HISTORIC AND DESIGN REVIEW COMMISSION

HDRC CASE NO: 2023-182
ADDRESS: 320 MADISON ST
LEGAL DESCRIPTION: NCB 744 BLK 3 LOT 16
ZONING: RM-4, H
CITY COUNCIL DIST.: 1
DISTRICT: King William Historic District
APPLICANT: Maggie Wilmoth
OWNER: Maggie Wilmoth
TYPE OF WORK: Construction of a 2-story rear accessory structure
APPLICATION RECEIVED: May 08, 2023
60-DAY REVIEW: Not applicable due to City Council Emergency Orders
CASE MANAGER: Rachel Rettaliata

The applicant is requesting a Certificate of Appropriateness to construct a 2-story rear accessory structure.

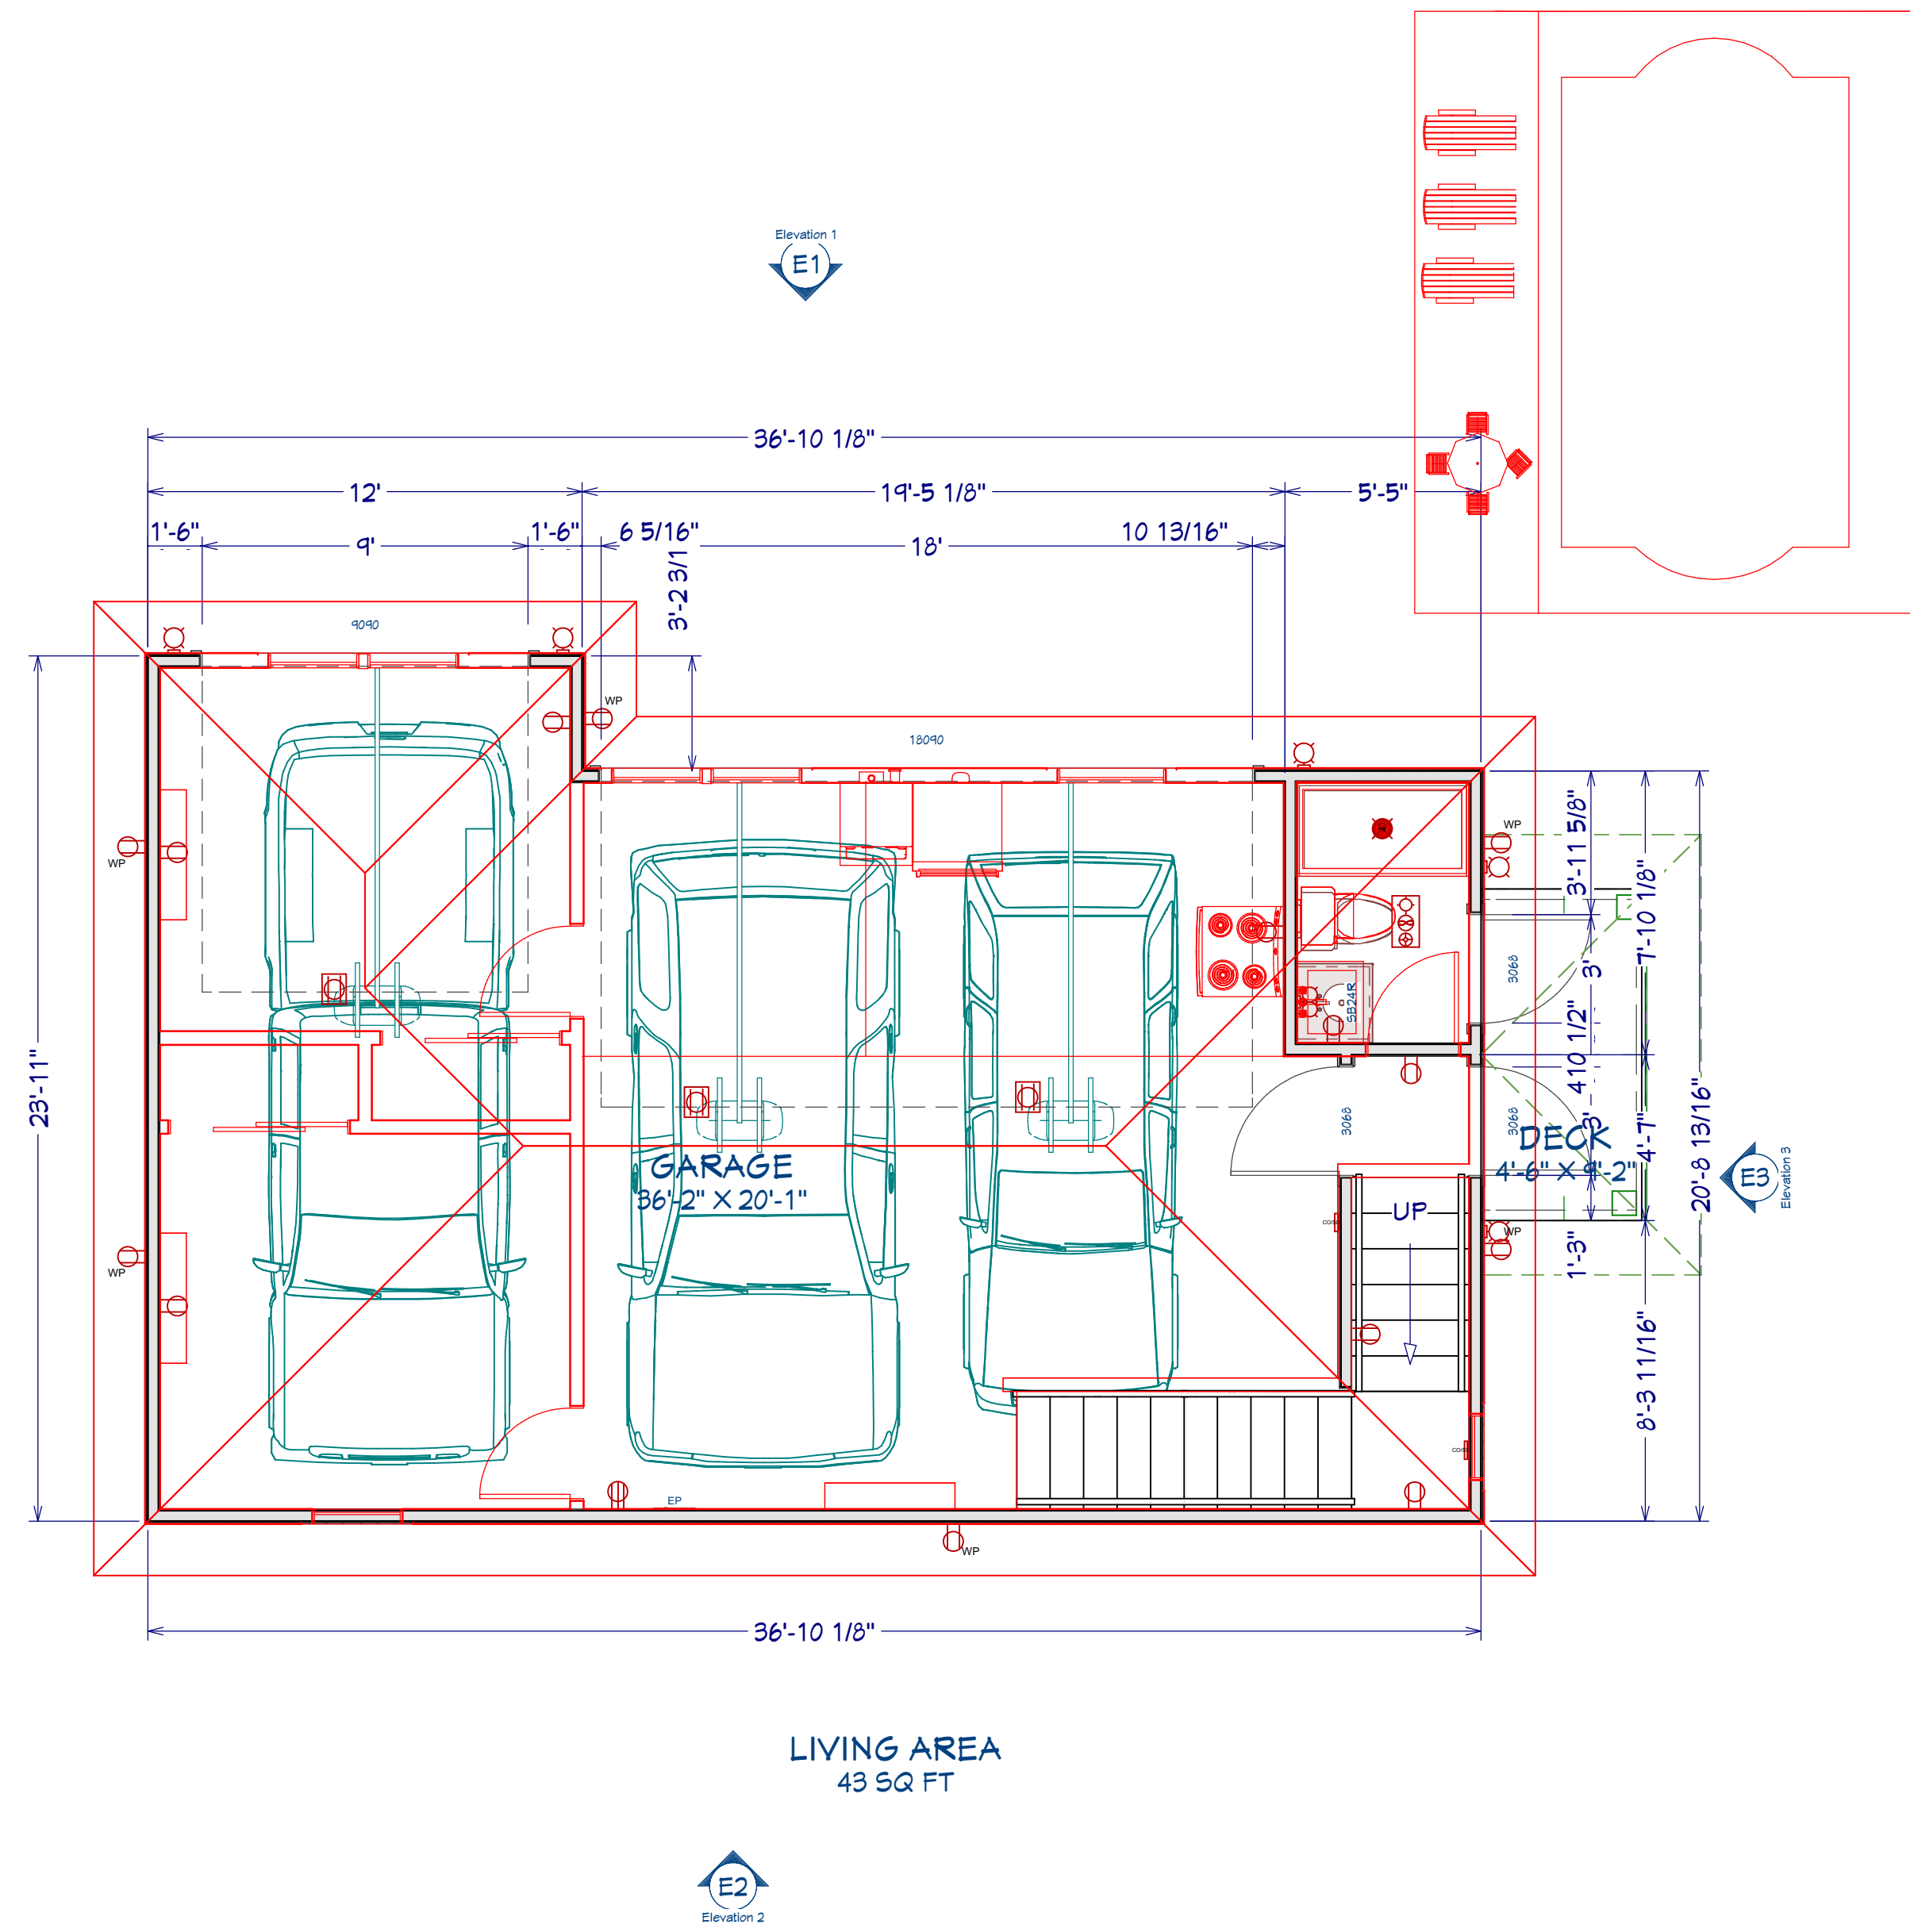
- i. That the applicant submits a comprehensive site plan showing the proposed setbacks to staff for review and approval prior to the issuance of a Certificate of Appropriateness based on finding c.

SURVEY & SITE PLAN SUBMITTED, GARAGE IS ON SAME SETBACK LINES AS PREVIOUSLY APPROVED w/ C of A - CHANGE IS FOR 2ND STORY

A-1

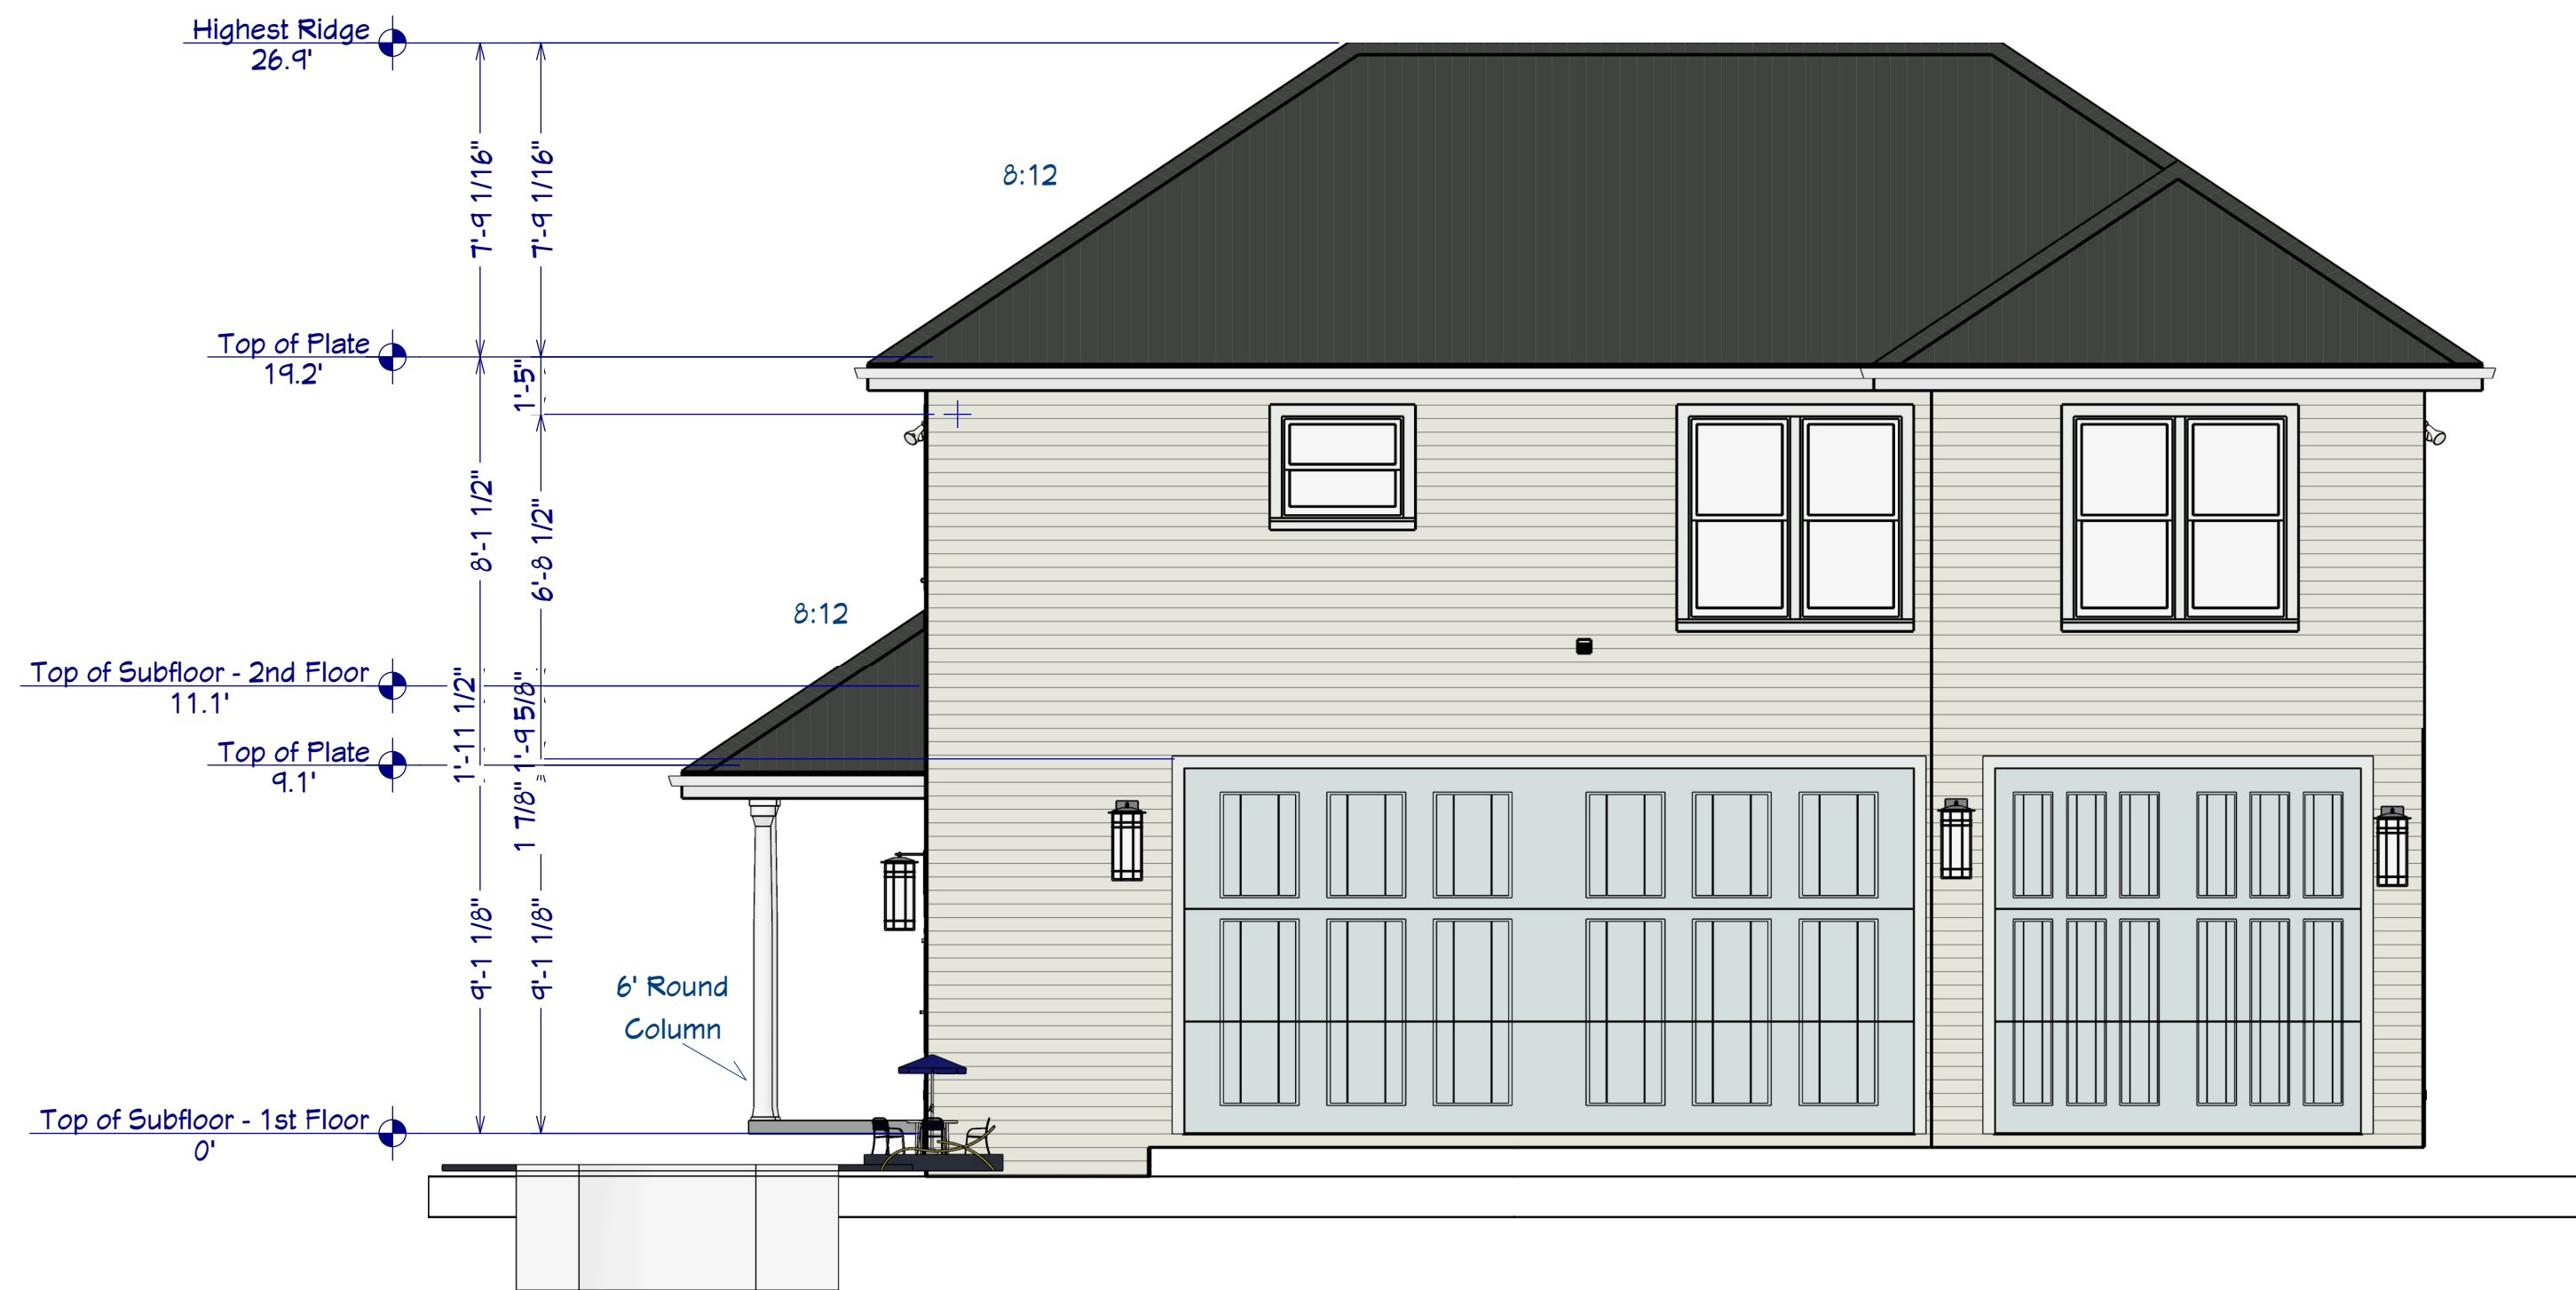
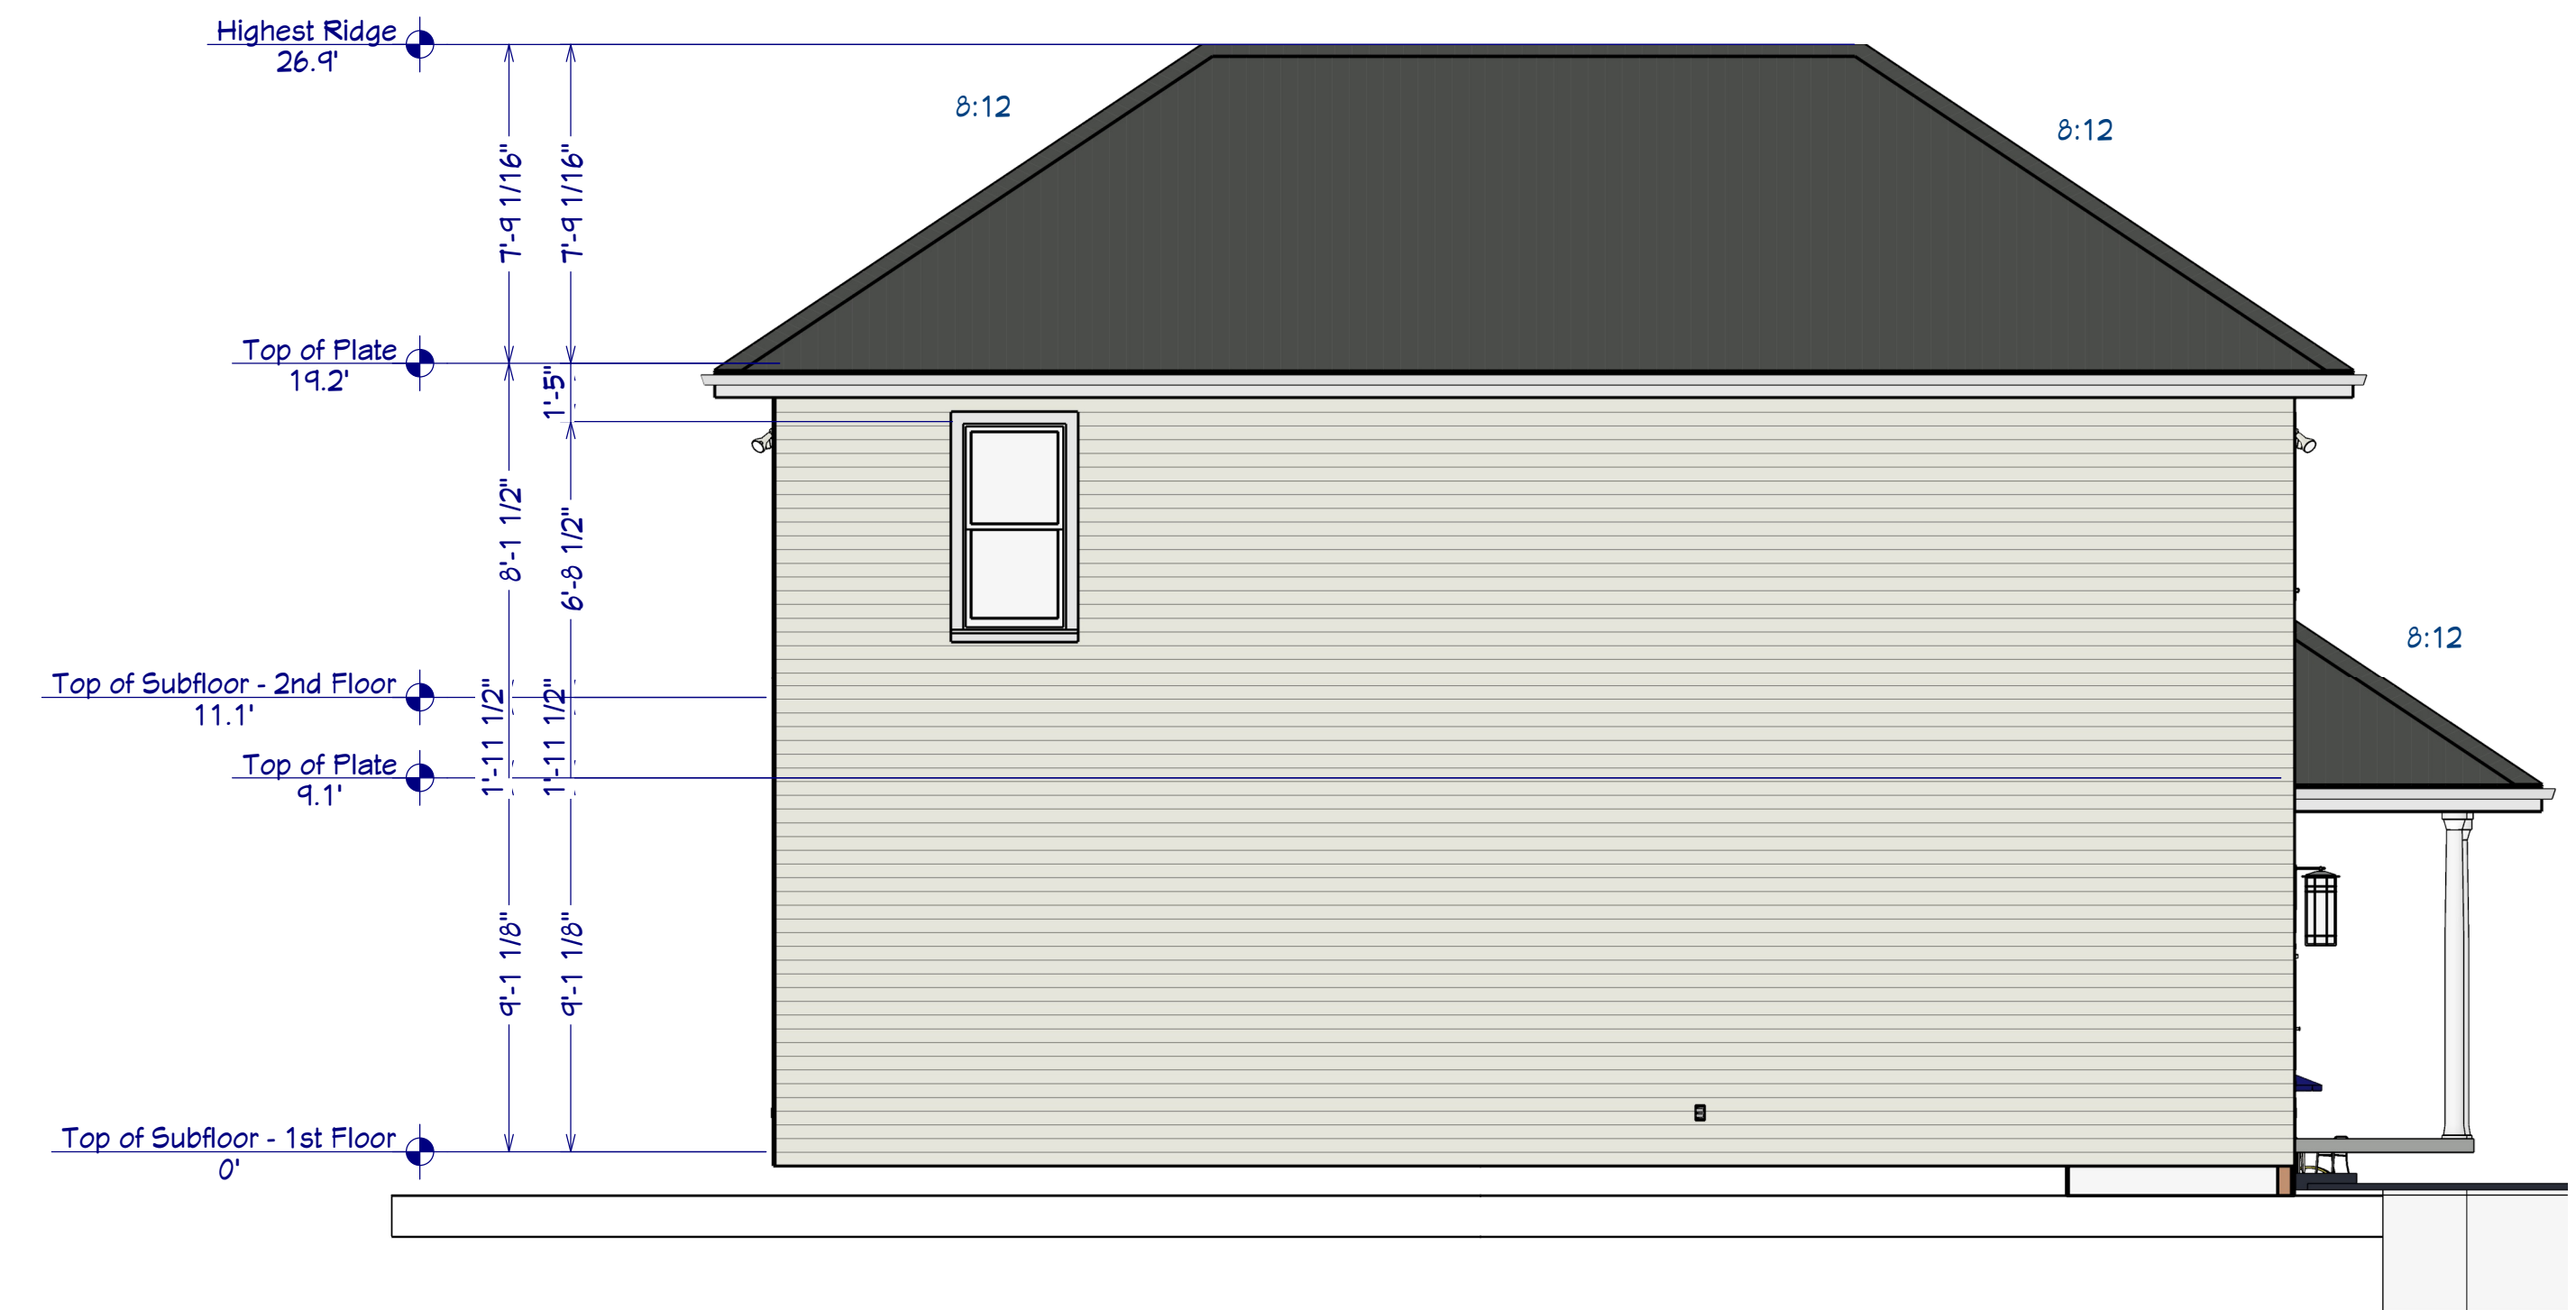
- i. That the applicant submits updated elevation drawings that propose architectural details that are in keeping with the Historic Design Guidelines and do not feature Juliet balconies based on finding j.

JULIET BALCONIES HAVE BEEN REMOVED
